**Technical Service  
BULLETIN**

**NAVIGATION SYSTEM SHOWS VEHICLE  
IN WRONG LOCATION**

'06 Sienna, '06 – '07 4Runner, & '07 Camry,  
Camry HV, & Solara

REVISÉD  
ELECTRICAL  
EL012-06

**Identification  
Method**

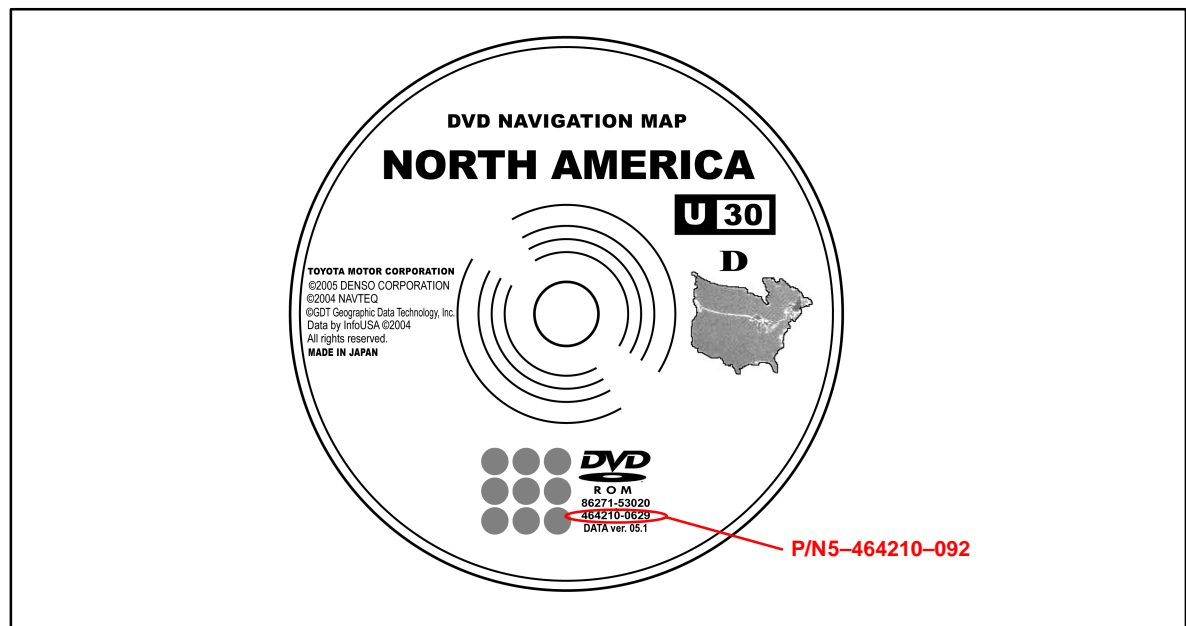
The map disc supplier part number changed to 5-464210-092. Refer to the following illustration to locate the supplier's part number (directly below the OEM part number):
